An Bord Pleanála Oral Hearing

Irish Water

Greater Dublin Drainage

**GDD Oral Hearing
Witness Statement of Alan Berry
Marine Water Quality**

Diagram 1: Predicted coliform concentrations over time at Velvet Strand bathing water sampling point

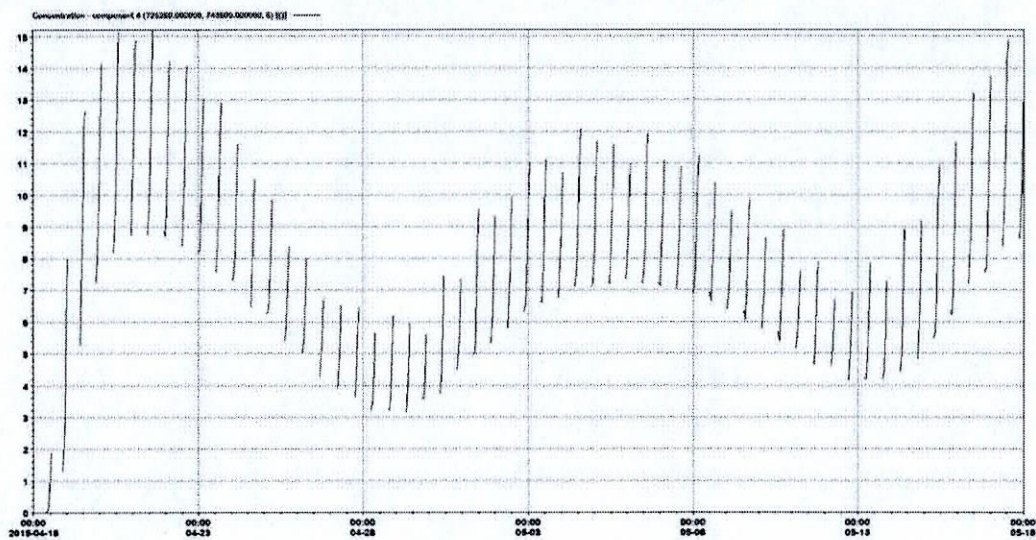
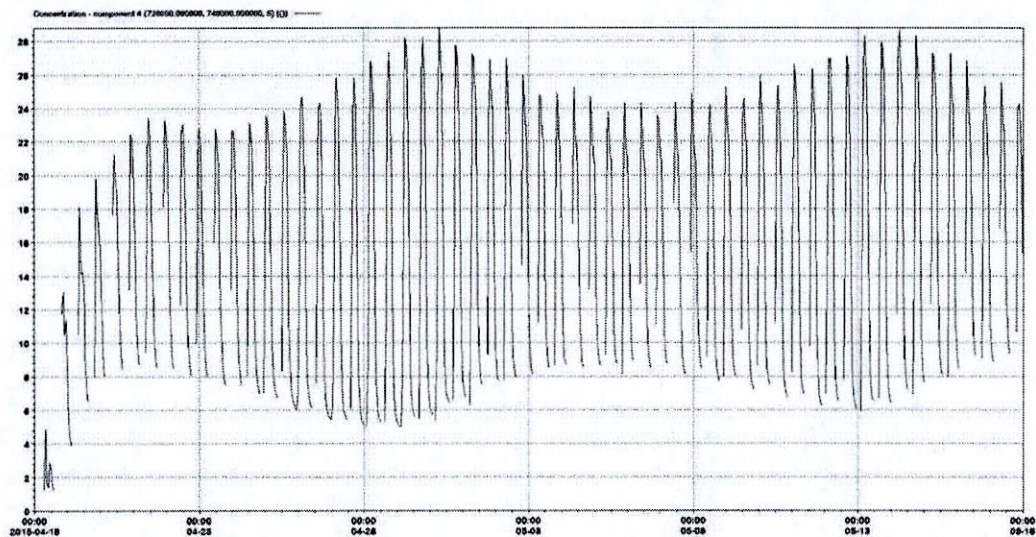
- 20 At Fingal County Council's request, additional modelling of the above scenarios (b) and (c) was undertaken to simulate Ringsend levels of treated wastewater coliform concentrations (300,000 cfu/100ml) discharging through the Proposed Project outfall point
- 21 Daily recorded coliform levels in the Ringsend effluent discharge for the period January – April 2018 ranged from 1,553 cfu/100ml to 241,960 cfu/100ml with the average coliform levels being 81,396 cfu/100ml.

- 23 Bathing Waters: For the revised scenario (b)(i), average daily flow, the predicted concentrations of coliforms over the course of the 30-day simulation did not exceed the 250 /100ml limit required to achieve 'Excellent' Status at any of the designated bathing waters areas. There was predicted to be no compliance failures at the designated bathing water beaches arising from the proposed discharge of treated wastewater containing higher coliform concentration levels of 300,000 cfu/100ml. The results of the Model predictions of coliform concentrations at the two closest designated bathing waters beaches, Velvet Strand and Claremont, are presented below in Diagram 1 and Diagram 2 respectively.

Diagram 3: Predicted coliform concentrations over time at Velvet Strand bathing water sampling point

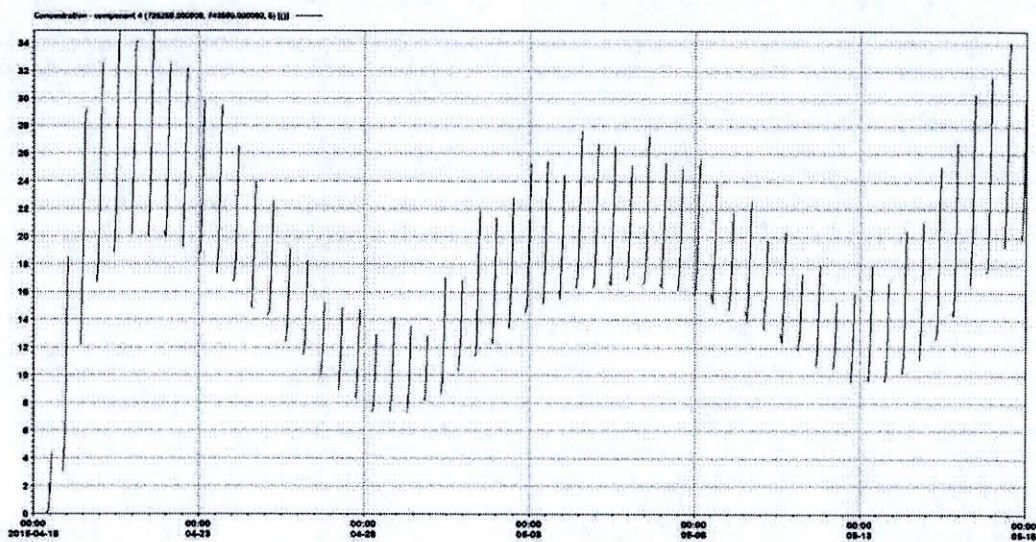
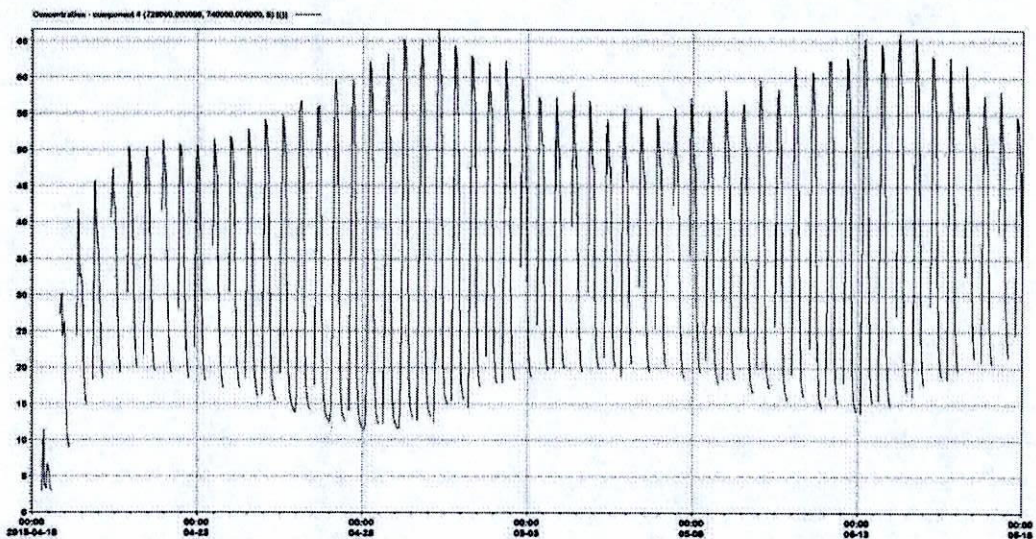
- 25 Bathing Waters: For the revised scenario (b)(ii), flow to full treatment, the predicted concentrations of coliforms did not exceed the 250 /100ml limit required to achieve 'Excellent' Status at any of the designated bathing waters areas. There was predicted to be no compliance failures at the designated bathing water beaches arising from the proposed discharge of treated wastewater containing higher coliform concentration levels of 300,000 cfu/100ml. The results of the Model predictions of coliform concentrations at the two closest designated bathing waters beaches, Velvet Strand and Claremont, are presented below in Diagram 3 and Diagram 4 respectively.

Diagram 5: Predicted coliform concentrations over time at Velvet Strand bathing water sampling point

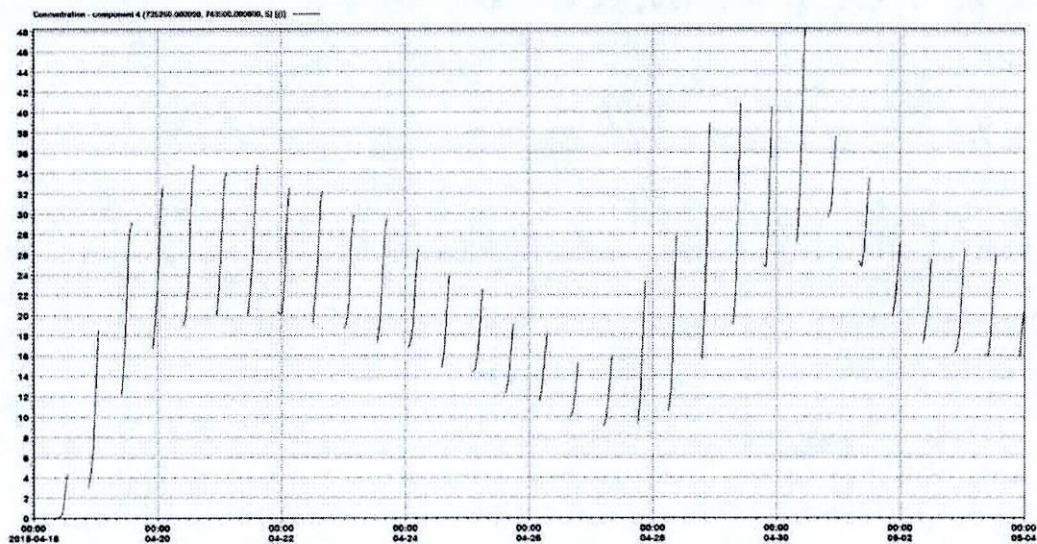
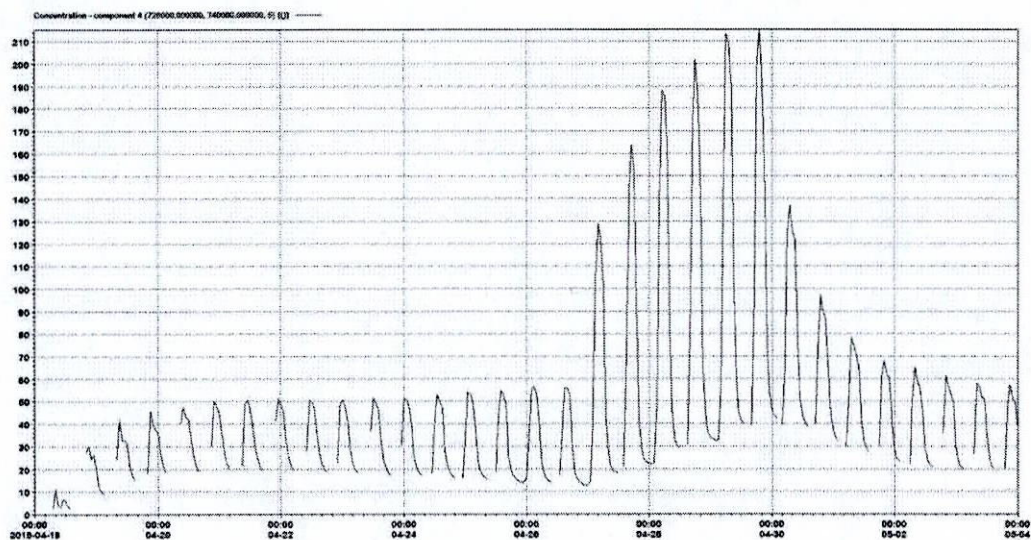
- 27 Bathing Waters: For the revised scenario (c), hypothetical 3-day process failure, the predicted concentrations of coliforms over the course of the simulation did not exceed the 250 /100ml limit required to achieve 'Excellent' Status at any of the designated bathing waters areas. There was predicted to be no compliance failures at the designated bathing water beaches arising from the proposed discharge of treated wastewater containing higher coliform concentration levels of 300,000 cfu/100ml. Though elevated coliform levels are predicted during the hypothetical process failure, the predicted coliforms levels return to prior levels three days after the end of the hypothetical process failure event. The results of the Model predictions of coliform concentrations at the two closest designated bathing waters beaches, Velvet Strand and Claremont, are presented below in Diagram 5 and Diagram 6 respectively.

Diagram 7: Multi-port Diffuser

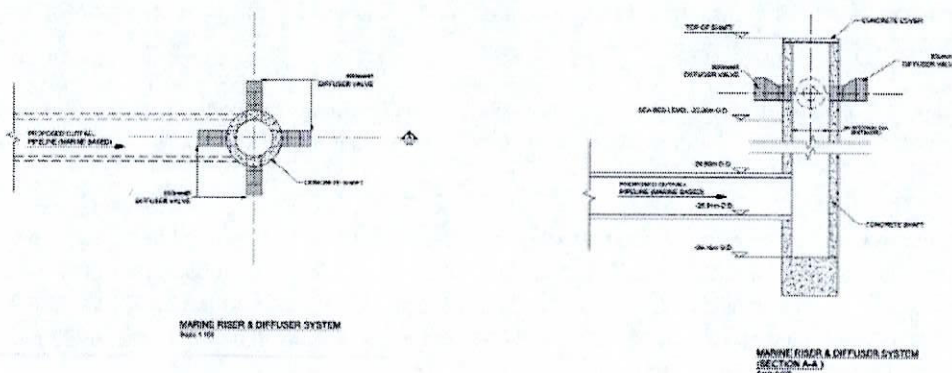
Issue #6 - size of marine diffuser to deal with discharge volumes

- 61 The proposed multi-port diffuser arrangement comprises a single riser pipe with four ports located 2m above the sea bed. The ports are to be positioned concentrically around the proposed outfall pipeline route (marine section), perpendicular to the sea bed. The Model considered the proposed multi-port diffuser as a virtual, single port of similar discharge characteristics in order to ascertain dilution characteristics in the receiving waters at distance from the proposed outfall pipeline route (marine section), and hence the mixing zone extents. The properties of the modelled single-port diffuser were equivalent to the combined area of the individual multi-port diffuser diameters and orientations. The virtual single port diffuser represented a 'maximum adverse scenario'. The actual multi-port diffuser will yield greater initial dilution than the modelled, virtual single port diffuser and is appropriately designed to deal with the proposed discharge volumes.
